2015 GROUP A PROPOSED CHANGES TO THE I-CODES MEMPHIS COMMITTEE ACTION HEARINGS

2015 GROUP A – PROPOSED CHANGES TO THE INTERNATIONAL RESIDENTIAL CODE – PLUMBING/MECHANICAL

TENTATIVE ORDER OF DISCUSSION 2015 PROPOSED CHANGES TO THE INTERNATIONAL RESIDENTIAL CODE (MECHANICAL)

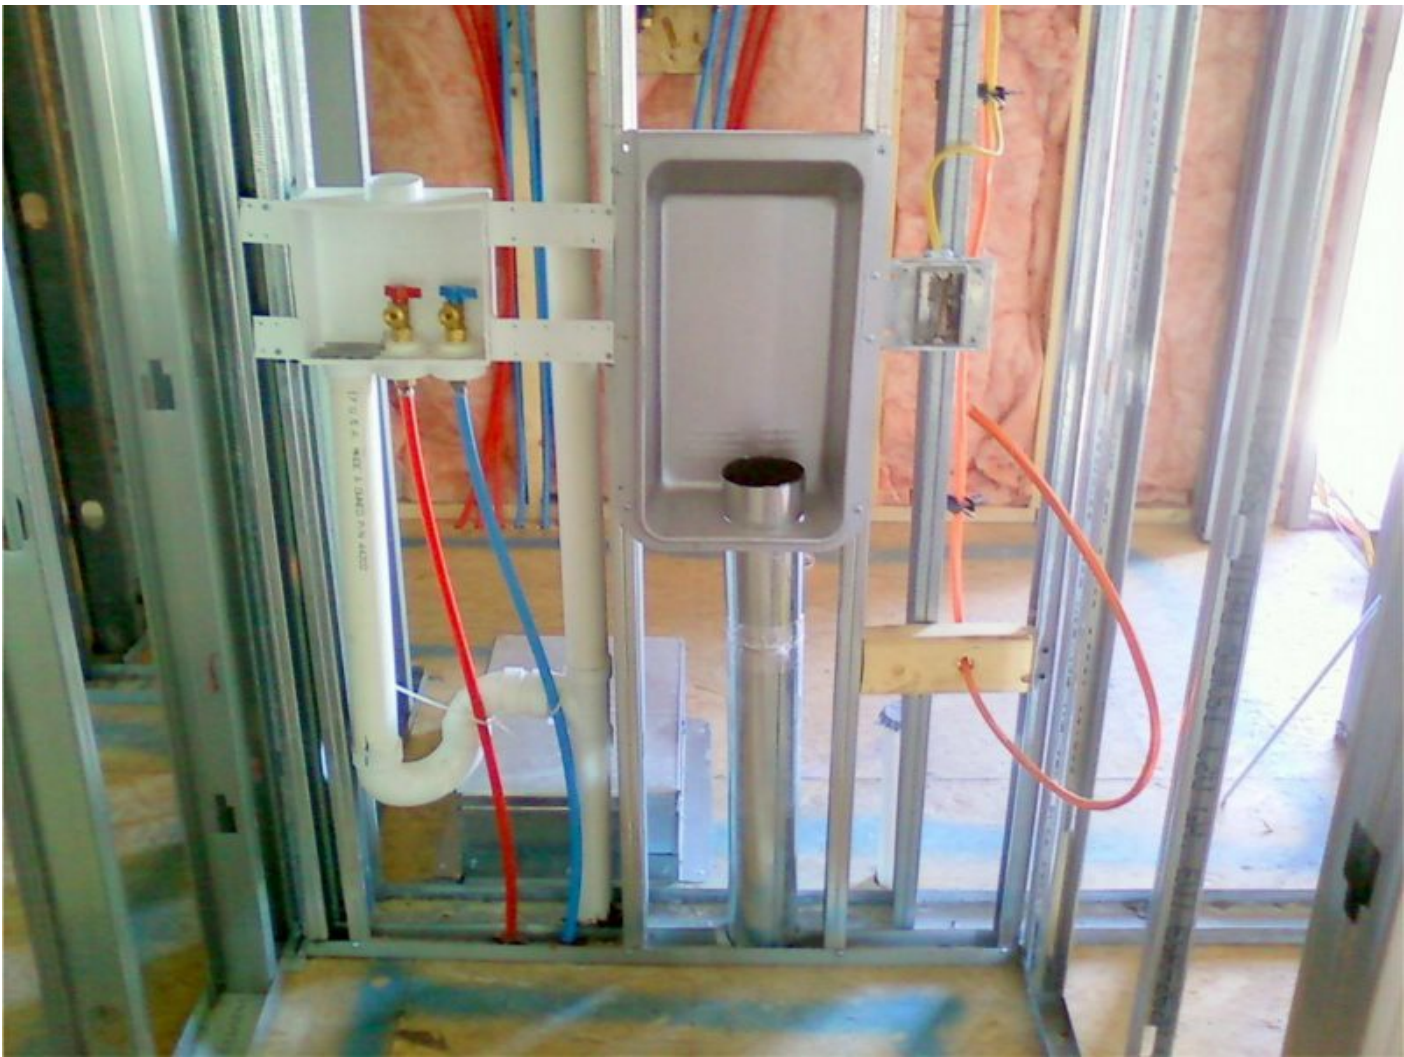
M1502.4.2 Duct installation. Exhaust ducts shall be supported at intervals not to exceed 12 feet (3658 mm) and shall be secured in place. The insert end of the duct shall extend into the adjoining duct or fitting in the direction of airflow. Exhaust duct joints shall be sealed in accordance with Section M1601.4.1 and shall be mechanically fastened. Ducts shall not be joined with screws or similar fasteners that protrude more than $\frac{1}{8}$ inch (3.2 mm) into the inside of the duct. Where dryer exhaust ducts are enclosed in wall or ceiling cavities, such cavities shall have a least dimension of not less than 4.25 inches (108 mm). Round ducts shall not be deformed.

A 1 inch furring strip (1x2) can be added to a 2 x 4 stud providing the 4.25 inches of space. In most cases, this "mechanical" wall is busy with other trades (plumbing drainage and vent stacks, gas piping, electric service, laundry services and water piping). A 4.25 inch space will benefit all of the trades working within that space. The minimum space required to keep the dryer exhaust duct round is 4.125 inches. This dimension could also be referenced here, however, most contractors

Examples of "mechanical walls" showing the abundance of utilities in this wall, demonstrating the need to provide more than 3.5"

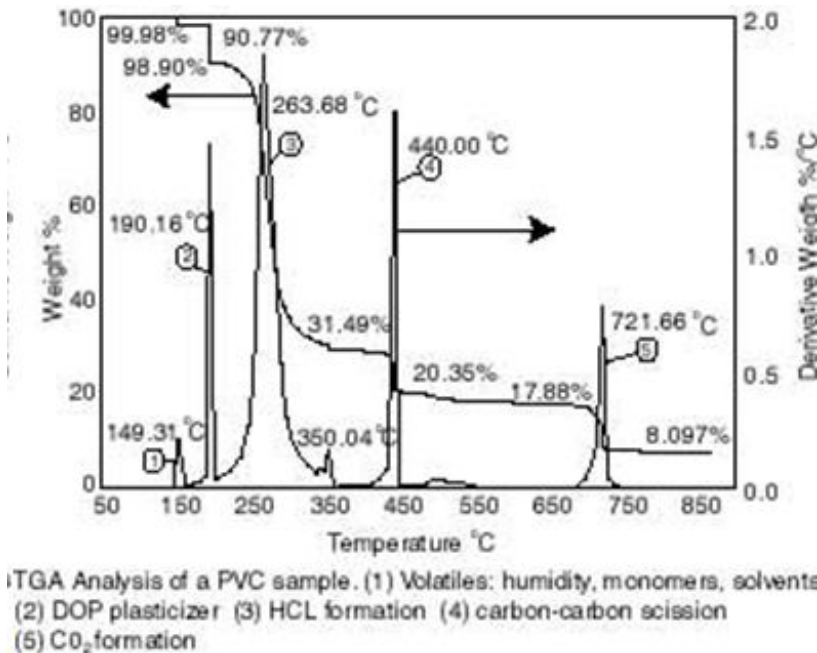
Reason: There is a need to more clearly support the use of above-ground plastic ducts in the International Residential Code (IRC) Section M1601.1.1. Plastic ducts appear to be "technically" allowed under this IRC Section but often receive rejection at the local jurisdiction level due to lack of specificity, clarity, and coherence, particularly in regards to the language of IRC Section M1601.2¹ and the International Mechanical Code (IMC) Section 603.8.3². Unclear and incomplete duct material requirements make using lower-cost, higher-performing duct systems unnecessarily difficult or impossible depending on interpretation at the local jurisdiction level.

Solvent welded assembly of plastic ducts inherently results in low air leakage and low airflow resistance. These relatively lower-cost materials are commonly available in appropriate small sizes for space conditioning airflow in low-load houses.

After researching the history, it was found that item 6 under Section M1601.1.1 was established specifically to allow polyethylene ducts, fittings and transitions (often blow-molded) to be used in above-ground duct systems. Based on feedback from industry stakeholders, building officials and ICC staff, the lack of clarity in this section regarding the intended material has been an ongoing problem. Calling out the intended polyethylene material will make this section clear and enforceable, clarifying that not only polyethylene fittings are allowed, but the duct system constructed of the same material.
